V2500-A1 SERIES PROPULSION SYSTEM SERVICE BULLETIN

This document transmits the Initial Issue of Service Bulletin V2500-ENG-72-0570

INFORMATION - ENGINE - PROVIDE NEW NO. 5 REAR BEARING HEAT SHIELD PART NUMBERS

LOCATION OF NO. 5 REAR BEARING HEAT SHIELD ASSEMBLY FIGURE 1

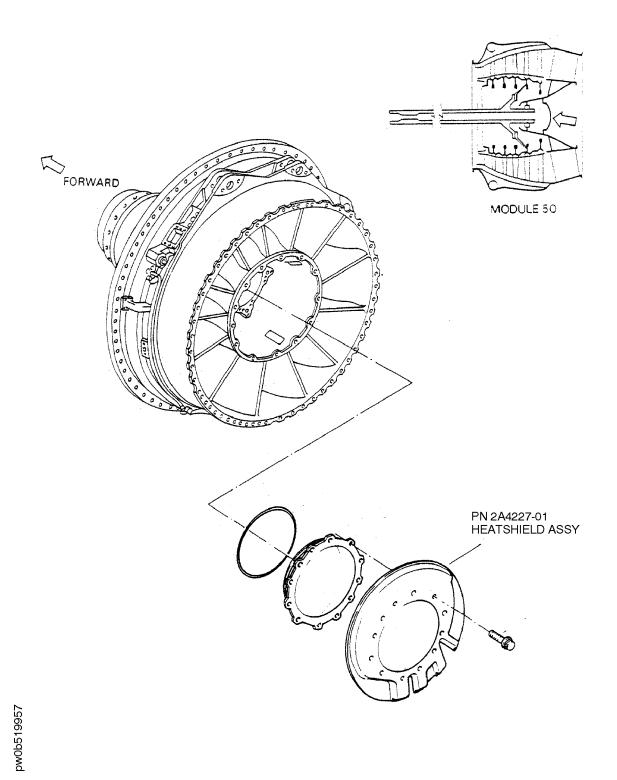
New Pratt & Whitney part numbers are being assigned to existing parts for compatibility.

FIG- ITEM NUMBER	NEW PART NUMBER	QTY	PART TITLE	MAT	OLD PN	INSTR - DISP
72-58-01						
01-100	2A4227-01	1	Heat Shield Assy, No. 5 Rear Bearing	. –	4T8030	(2)(A)(C) (I)(S1)
72-50-53						
01-372	2A4226-01	1	Heat Shield, Lower	-	4T8046	(2)(B)(C) (I)(S1)
01-382	2A4228-01	1	Heat Shield, Upper	-	4T8047	(2)(B)(C) (1)(S1)

Reidentified Parts New PN	Data Keyword	Old PN
2A4226-01	No. 5 Rear Bearing Lower Heat Shield	4T8046
2A4228-01	No. 5 Rear Bearing Upper Heat Shield	4T8047
2A4227-01	No. 5 Rear Bearing Heat Shield Assy	4T8030
